Product Change Notice (PCN)

Subject: Change in Marking Format on Select DFN-8 Package

Publication Date: 12/28/2023

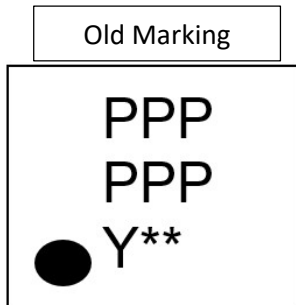
Renesas is changing the marking format for Line 3 as shown in the below diagram.

where Line 1 and 2: Product part no

Line 3: Y is last digit of the Year

** is sequential code

where Line 1 and 2: Product part no

Line 3: Y is last digit of the Year

W is 1 digit Workweek Code

* is sequential code

Underline to differentiate assembly house
